Product Change Notification / KSRA-18BGHS695

CCB 4559 Final Notice: Qualification of SIGN as a new assembly site for selected SST39LFxxxx and SST39VFxxxx device families available in 48L TSOP (12x20mm) package.

**CCB 4559**  
**Pre and Post Change Summary**  
**PCN # KSRA-18BGHS695**

# Lead frame Comparison

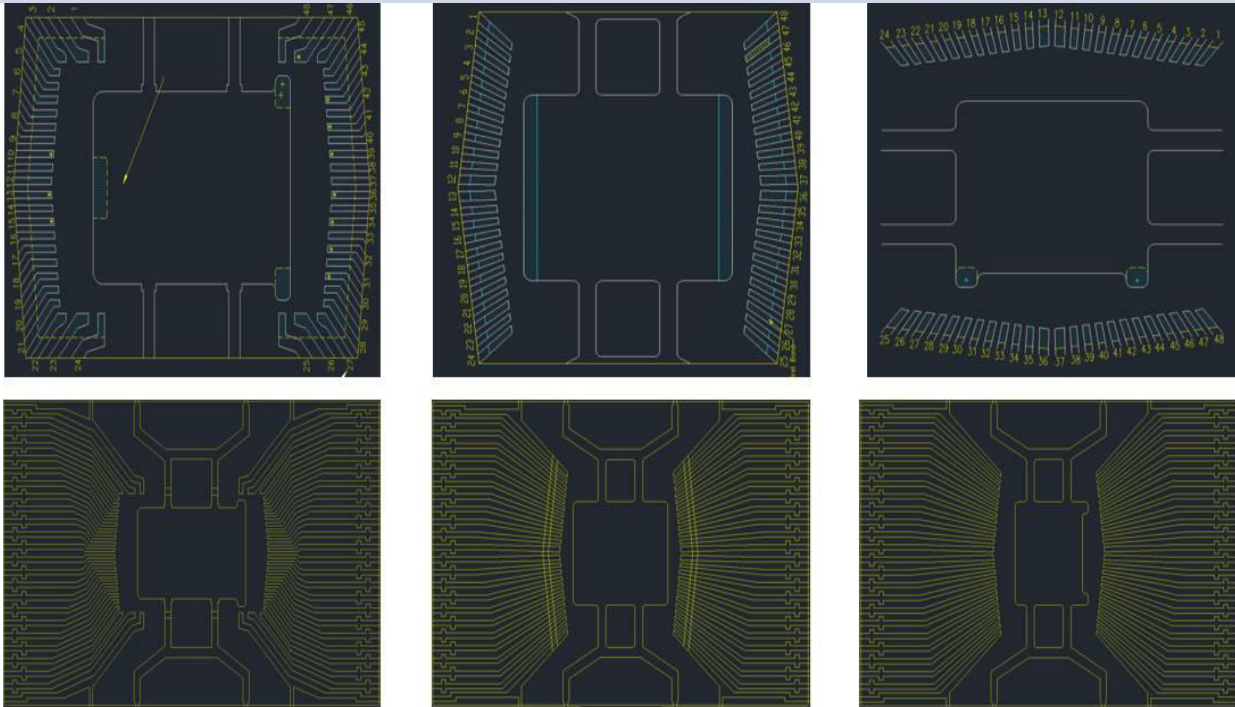
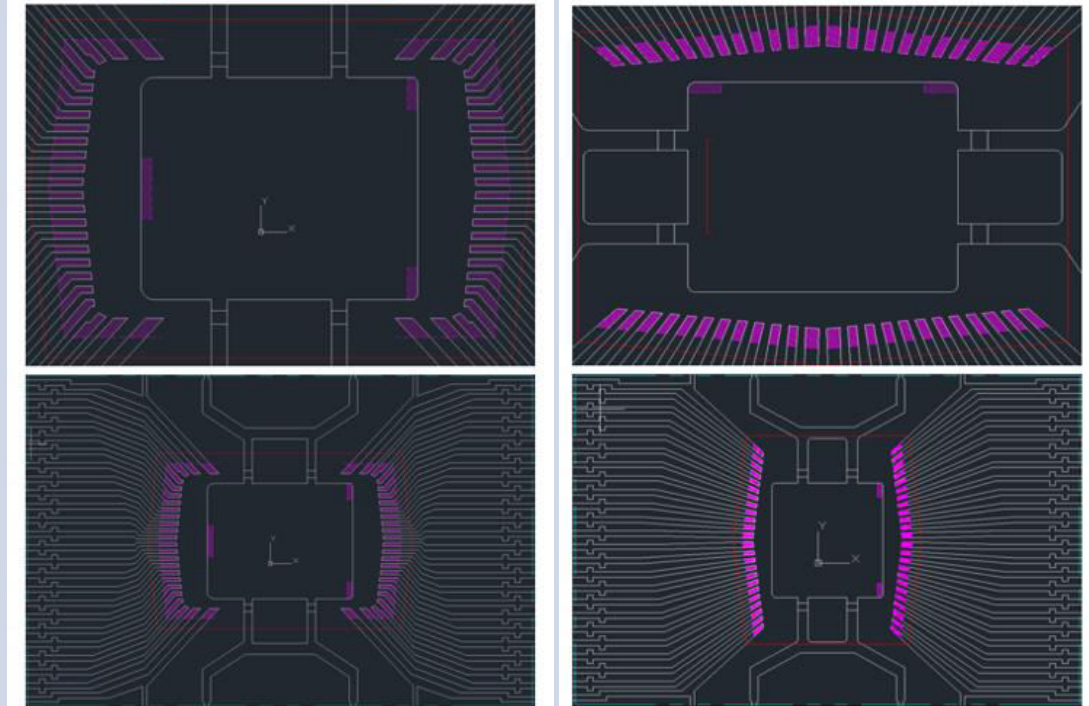
Assembled at LPI using 8340 die attach material and lead frame with paddle size 207x142mils, 183x161mils or 160x130mils.

Assembled at SIGN using AP-4300 die attach material and lead frame with paddle size 209x165mils or 159x165mils
